From: [Chris Glenn](#)
To: [Zech, Myriam@Waterboards](mailto:Zech.Myriam@Waterboards); [Forman, Keith S CIV NAVFAC HQ, BRAC PMO](mailto:Forman.Keith.S.CIV.NAVFAC.HQ.BRAC.PMO); [Kimberly Noble](mailto:Kimberly.Noble)
Cc: [Clark, David J CIV](mailto:Clark.David.J.CIV); [Naugle, Alec@Waterboards](mailto:Naugle.Alec@Waterboards); bob.beck@SFGOV1.onmicrosoft.com
Subject: RE: Water Board comments on the Draft ROD-RAP Site 32
Date: Wednesday, March 02, 2016 15:02:35
Attachments: [SLR.PDF](#)

From: Zech, Myriam@Waterboards [<mailto:Myriam.Zech@waterboards.ca.gov>]
Sent: Wednesday, March 02, 2016 2:27 PM
To: Forman, Keith S CIV NAVFACHQ, BRAC PMO (keith.s.forman@navy.mil); kimberly@marrscorp.com
Cc: Clark, David J CIV NAVFAC SW; Sunga, Remedios@DTSC; Naugle, Alec@Waterboards;
Burke.NadiaHollan@epa.gov; Beck, Bob (MYR) (bob.beck@SFGOV1.onmicrosoft.com)
(bob.beck@SFGOV1.onmicrosoft.com) (bob.beck@SFGOV1.onmicrosoft.com); Chris Glenn; O'Sullivan, Jessica
(Jessica.OSullivan@tetratech.com); William Carson
Subject: Water Board comments on the Draft ROD-RAP Site 32

FIGURE 6.4 SEA LEVEL RISE STRATEGY SITE PLAN DIAGRAM

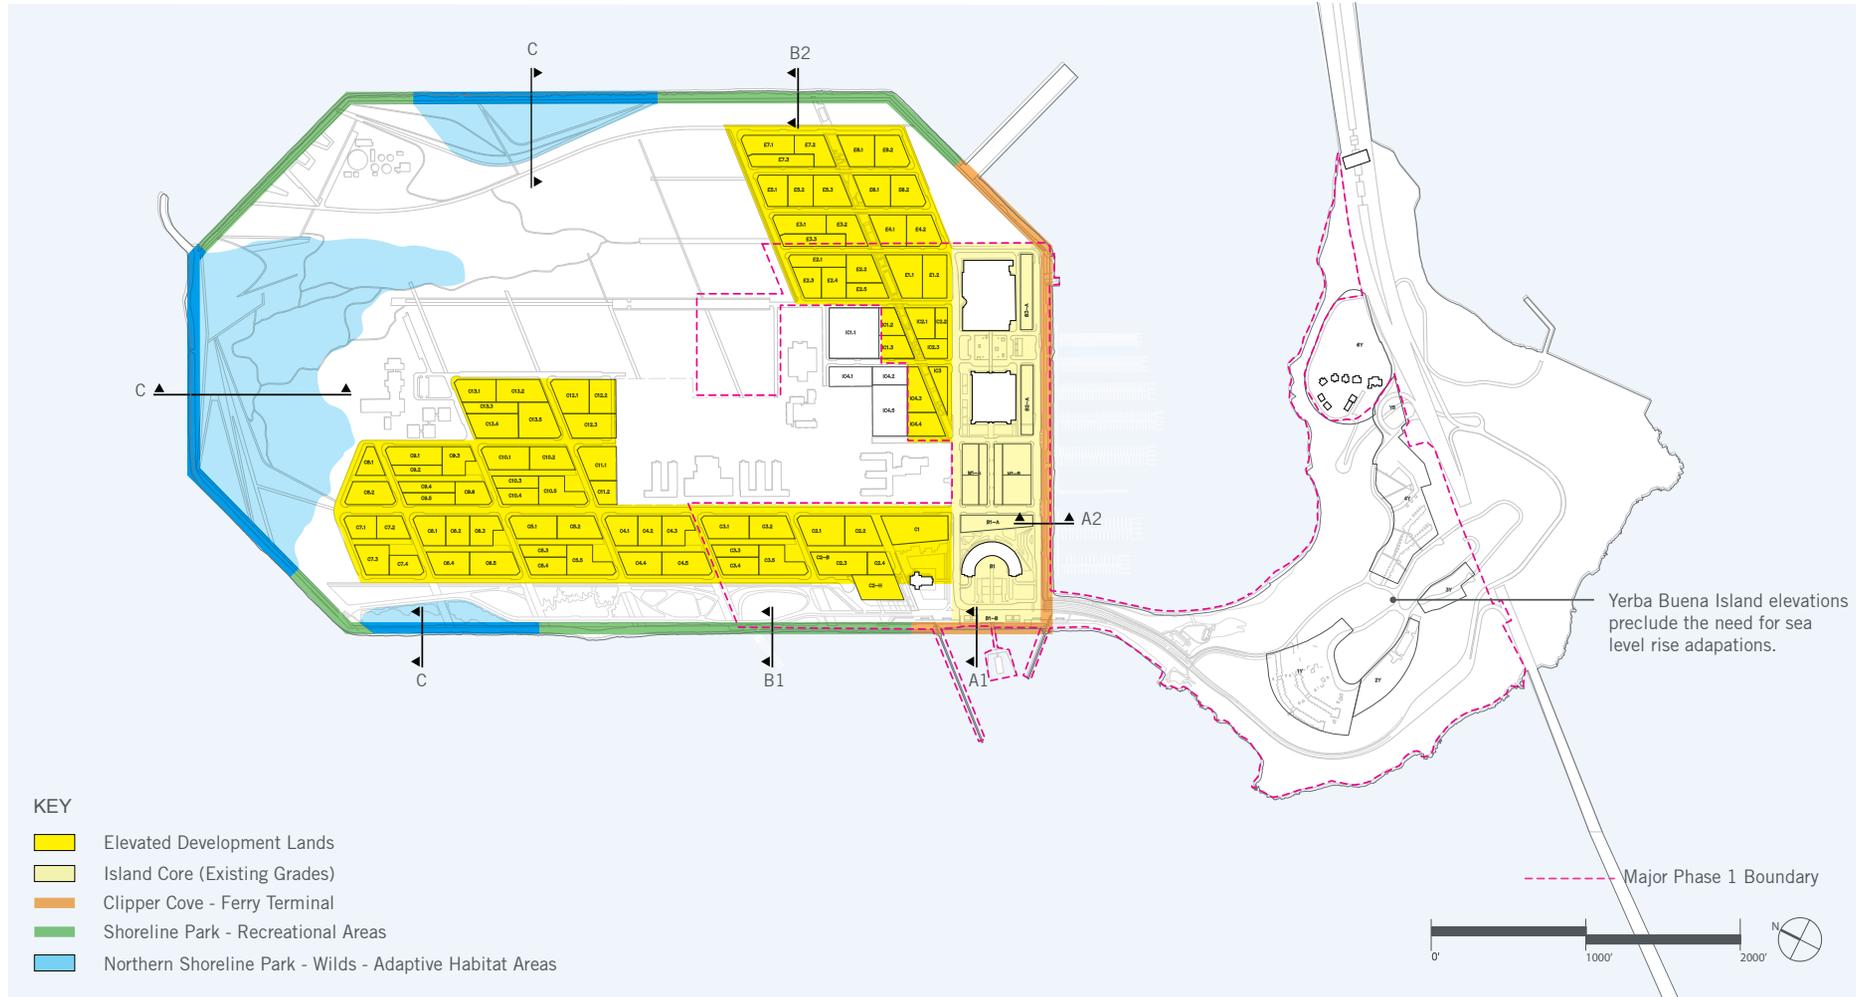
To provide some context on Myriam's specific comment #2 regarding potential future ecological habitat at Site 32: I've attached the sea level rise adaptation strategy figure for Treasure Island, showing certain areas which, as a contingency if SLR is greater than planned, could be adapted into tidal marshland areas. Site 32 is not one of these areas. Also, while a freshwater wetland is being considered near the future wastewater treatment plant, the development plans do not show it within Site 32. The 2011 development plan shows the wetland bordering or slightly entering Site 6, so the language in the Site 6 ROD was appropriate, but I think this is not the case for Site 32.
